Your Ref
APP/13/01257
Our Ref
PLAN-005138
Date
16/01/2014

Proposal: Demolition of existing single storey building (class A2) and associated outbuilding to the rear; construction of 4 storey building comprising 7No. 1 bed and 4No. 2 bed apartments with associated landscaping, cycle parking and refuse provision.
Site: 9 East Street, Havant, PO9 1AA.
APP/13/01257

Southern Water MapGuide Browser

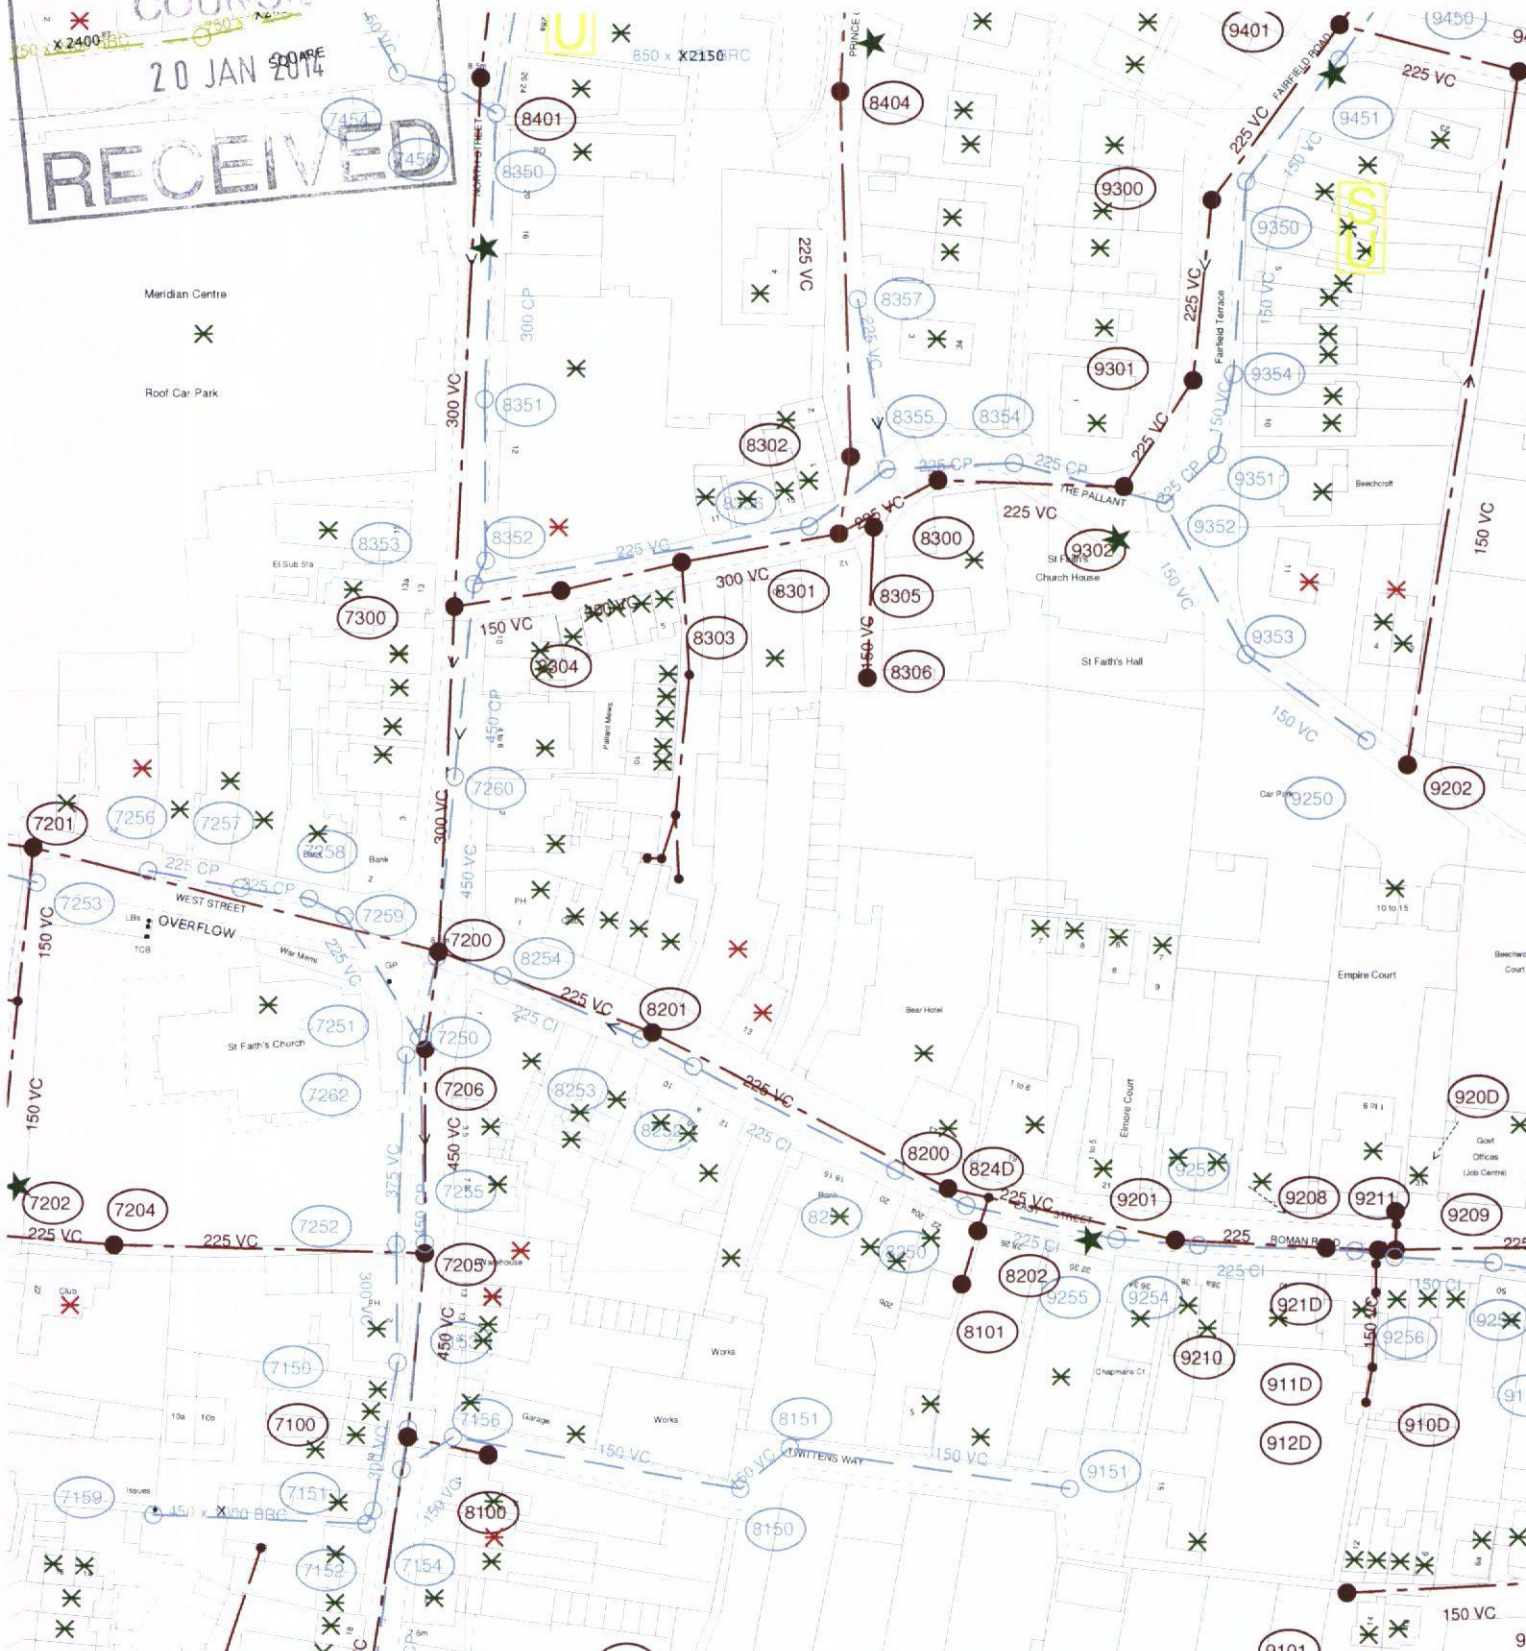
Please find attached a plan of the sewer records showing the approximate position of a public foul sewer crossing the site. The exact position of the public sewers must be determined on site by the applicant before the layout of the proposed development is finalised.

It might be possible to divert the public sewer, so long as this would result in no unacceptable loss of hydraulic capacity, and the work was carried out at the developer's expense to the satisfaction of Southern Water under the relevant statutory provisions.

1. The foul sewer requires a clearance of 3 metres either side of the sewer to protect it from construction works and allow for future access for maintenance.
2. No development or new tree planting should be located within 3 metres either side of the centreline of the public sewer
3. No new soakaways should be located within 5 metres of a public sewer.
4. All other existing infrastructure should be protected during the course of construction works.

In order to divert/protect drainage apparatus, Southern Water requests that if consent is granted, a condition is attached to the planning permission. For example "The developer must advise the local authority (in consultation with Southern Water) of the measures which will be undertaken to divert the public sewers, prior to the commencement of the development."
